**Re: Design Submission for Former Hickey & co ltd, Park gate street, Dublin, Dublin
(the “Development”)
(the “Design Submission”) / Connection Reference No: CDS23006543**

We have reviewed your proposal for the connection(s) at the Development. Based on the information provided, which included the documents outlined in Appendix A to this letter, Uisce Éireann has no objection to your proposals.

Drawing Title: Permitted Drainage & Watermain Layout with Proposed Block B2 Amendment

Drawing Title: Longitudinal Foul Drainage Sections

Role	Civil
Suitability	S2 - Suitable for Information
Arup Job No	265381-00
Name	Rev C10
PGATE-ARUP-ZZ-00-DR-CD-0002

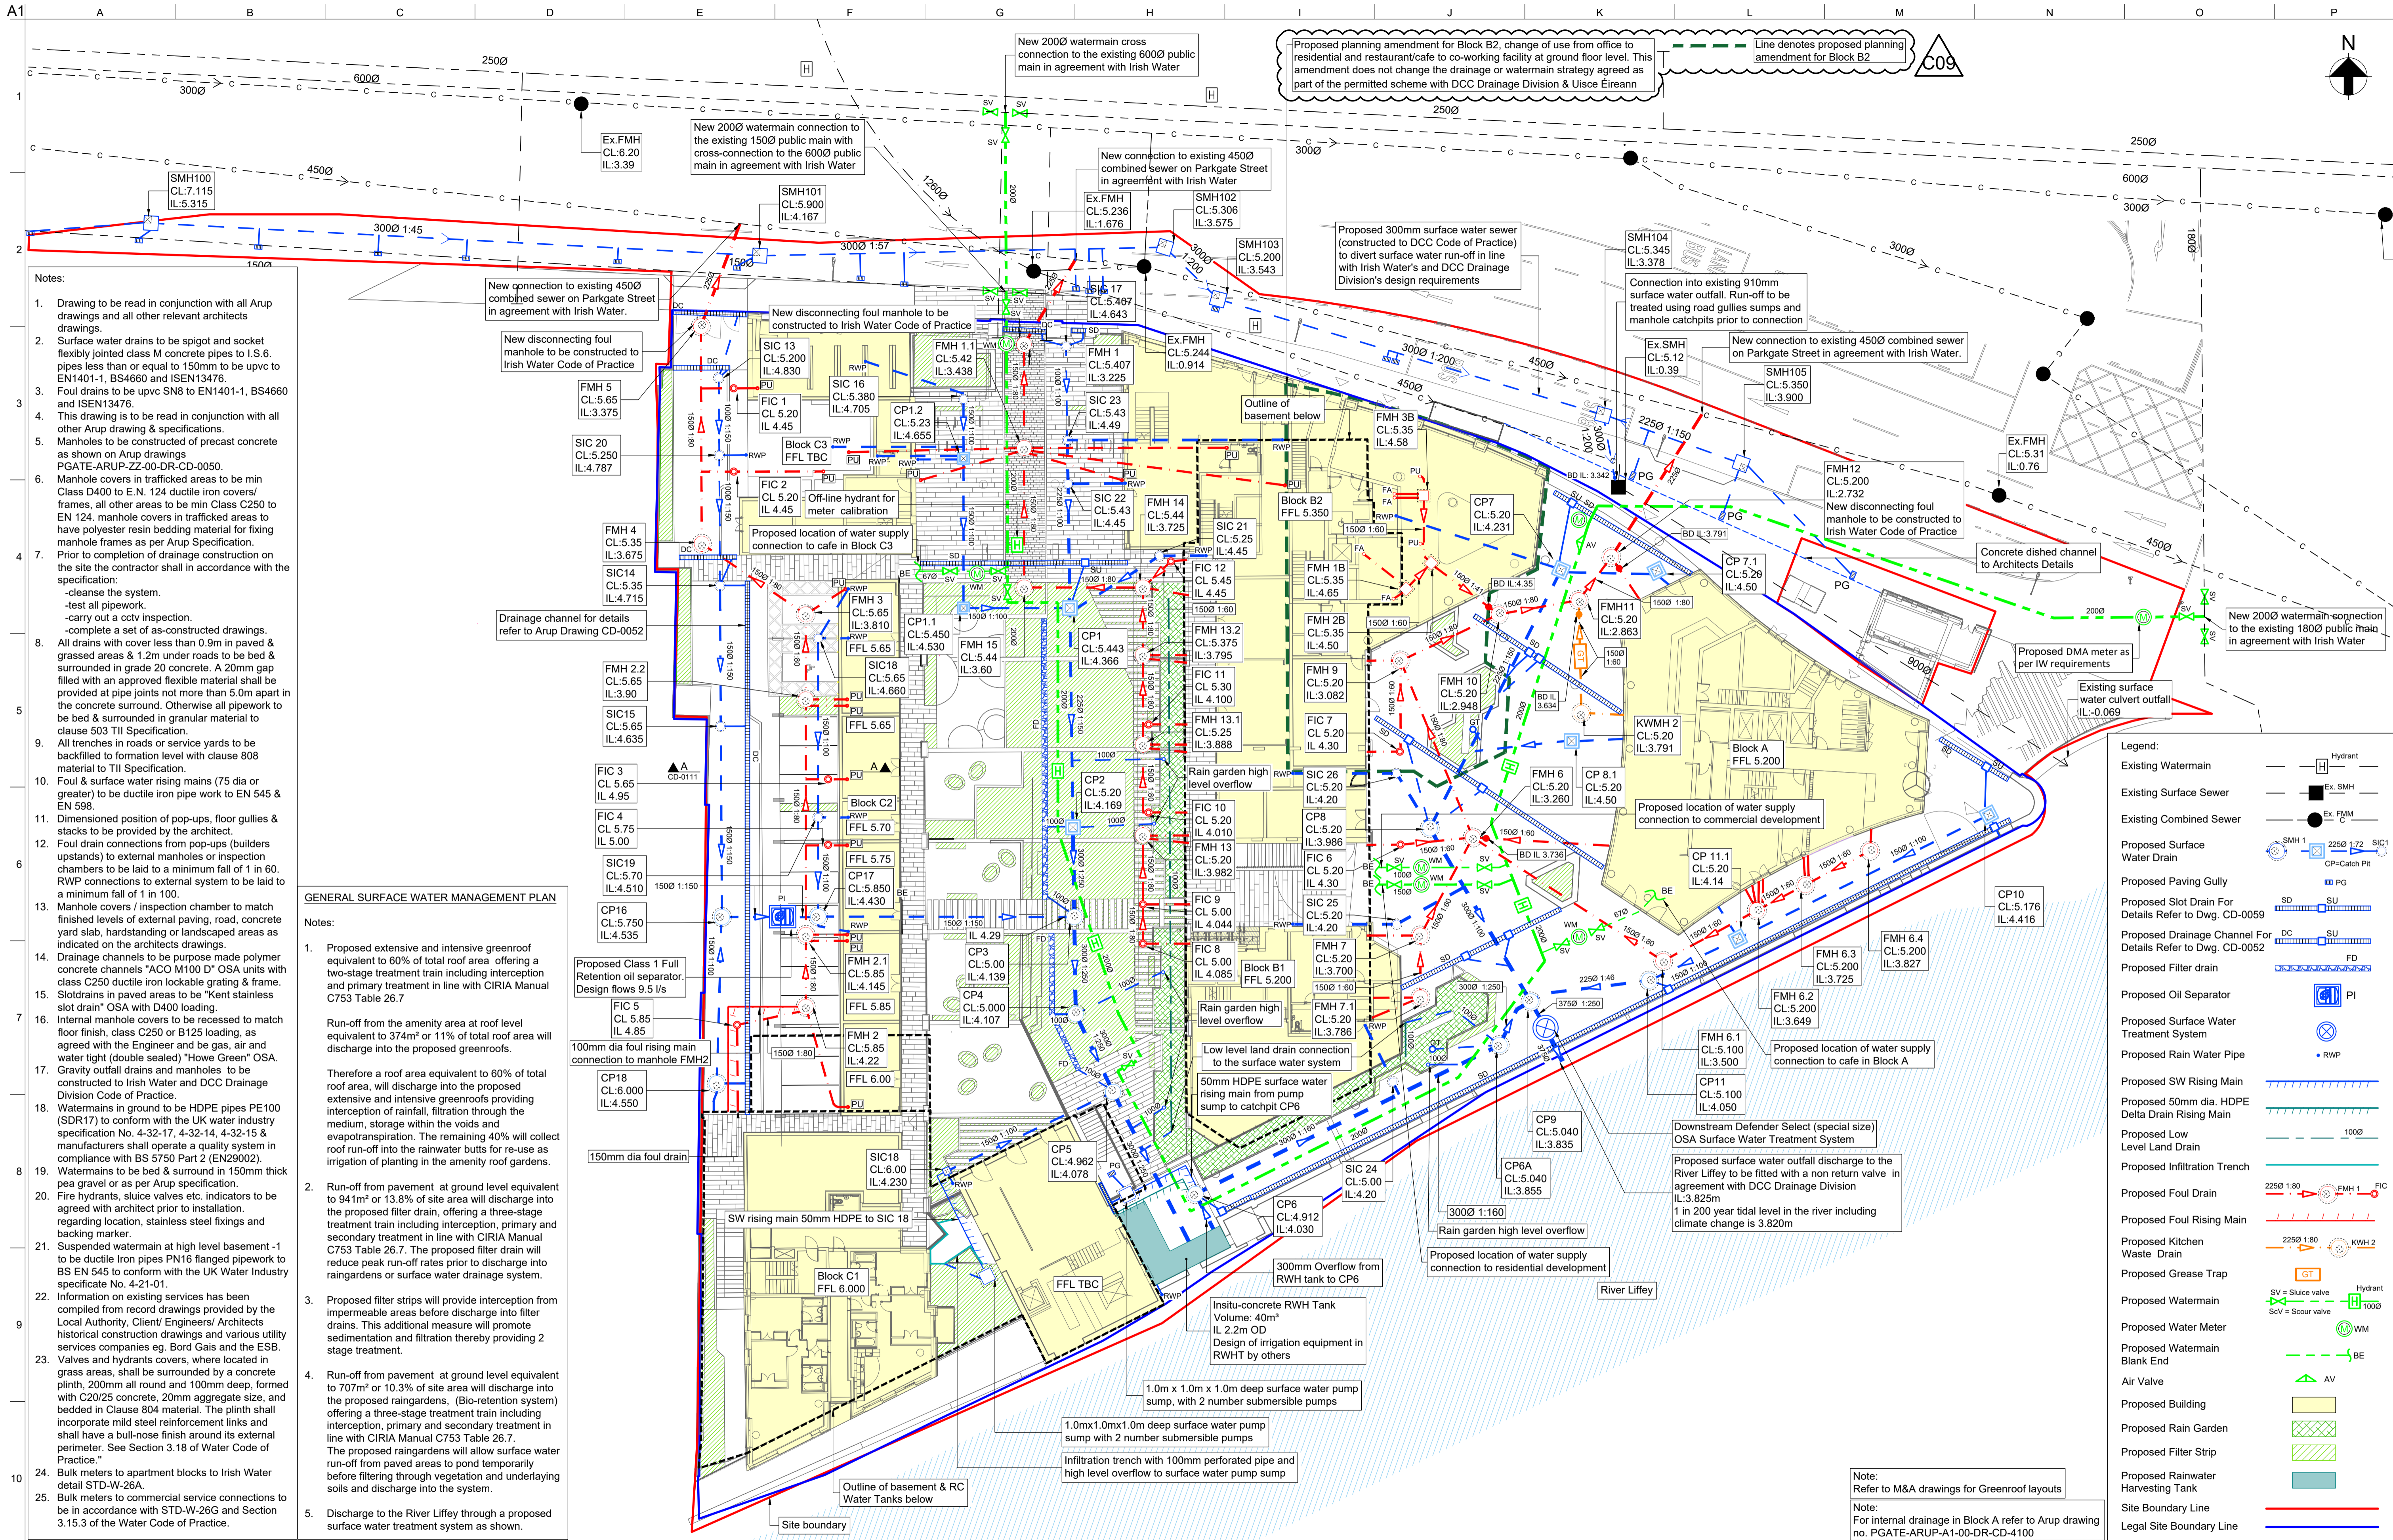
1. *Final connection with the public network and manhole arrangements to be agreed at Connection Application stage.*

While Uisce Éireann notes that the water and wastewater services infrastructure will remain private and not be vested, we have the following comments: It is recommended that the watermain and foul sewer shall have 3 m clearance from proposed or existing structures.
